SERVICE TECHNICAL INFORMATION

REF. NO.: SI-98-031

MODEL : NSX-A303 and A304

SUBJECT : Addition or replacement of relay circuit

1. Identification method

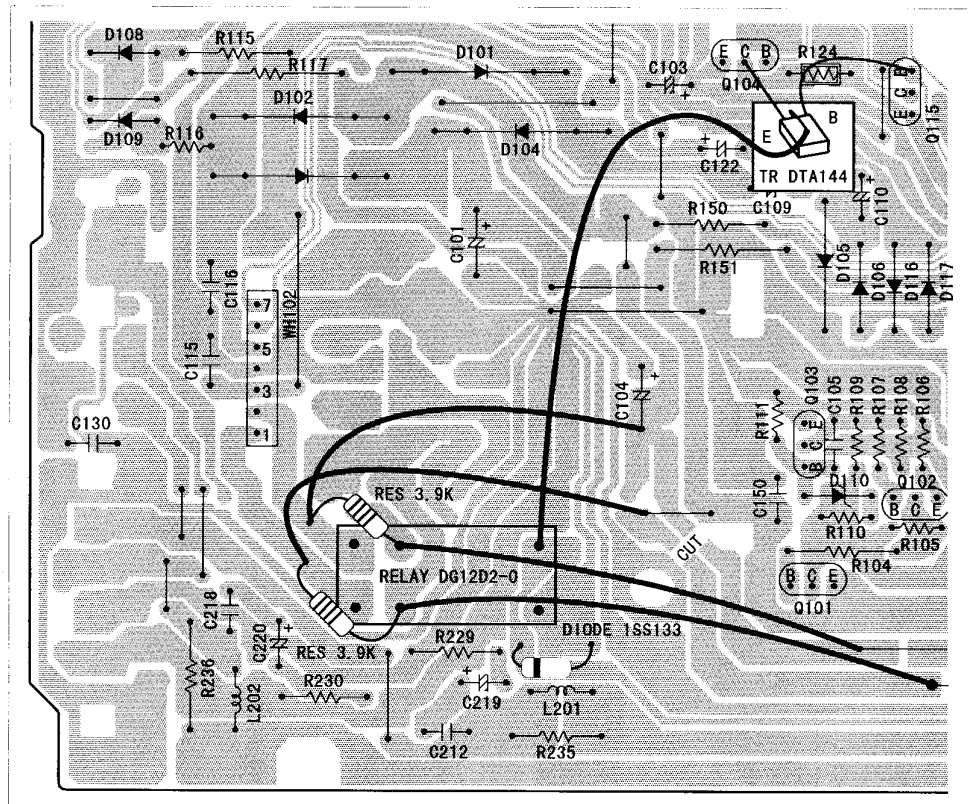
Relay circuit has been added to the units with "A" mark (white "A" letter on red) labels put on rear panel.

2. Pattern diagram

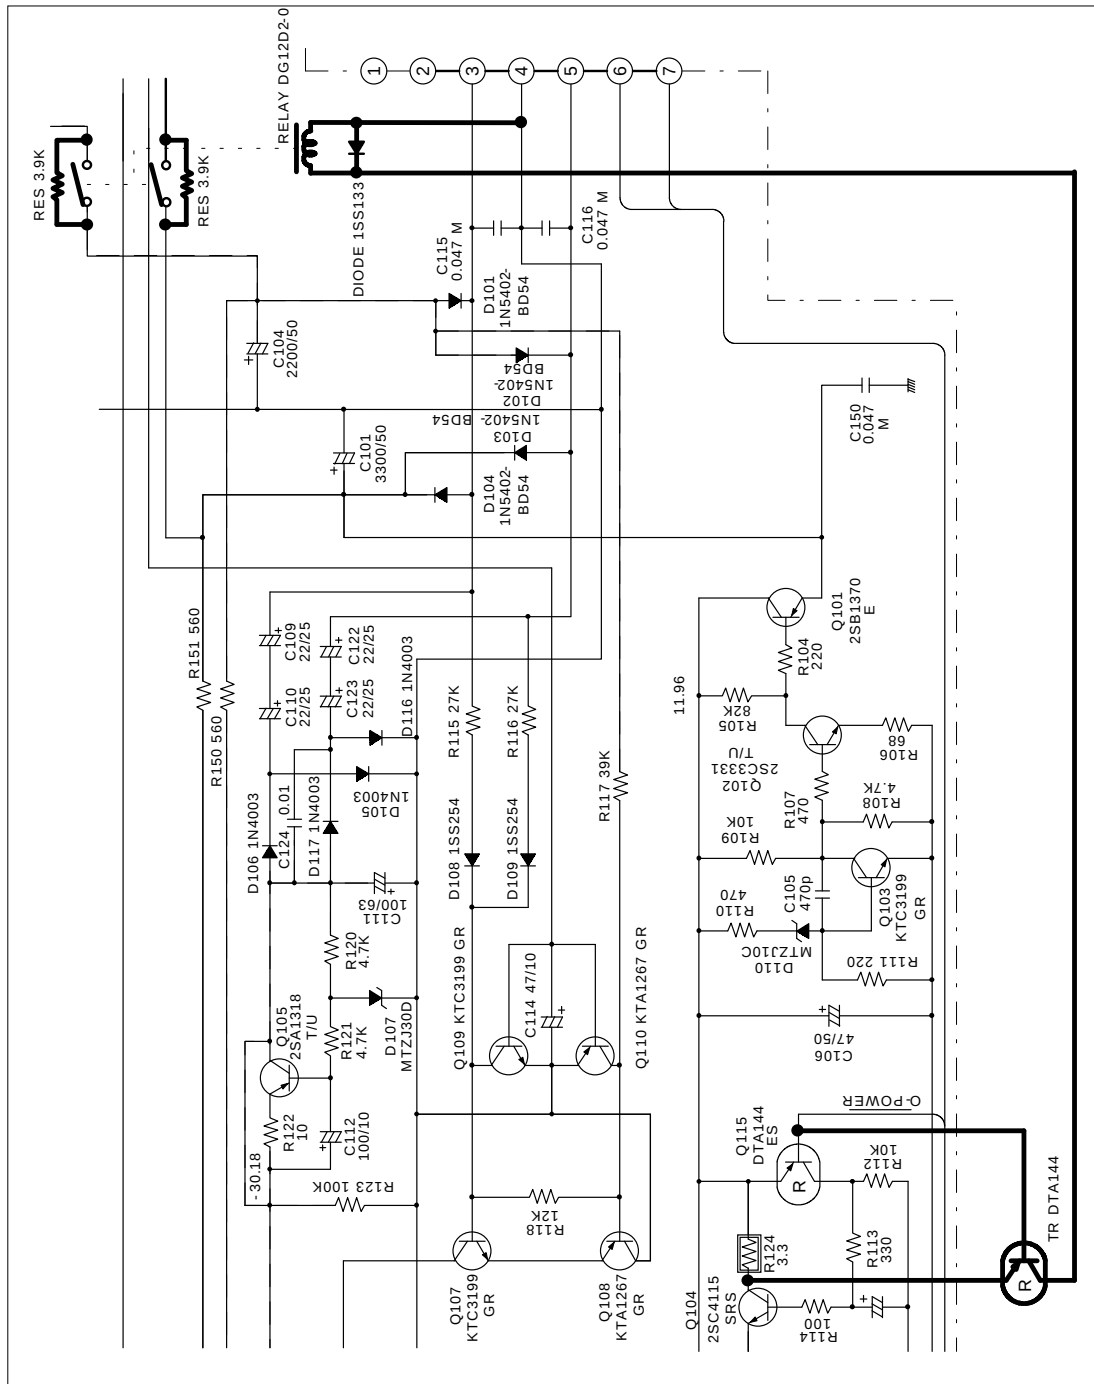
Relay circuit has been added to some of the products of the above models.

Before repairing, refer to the following identification method and circuit diagram, pattern diagram, and replacement parts list for details.
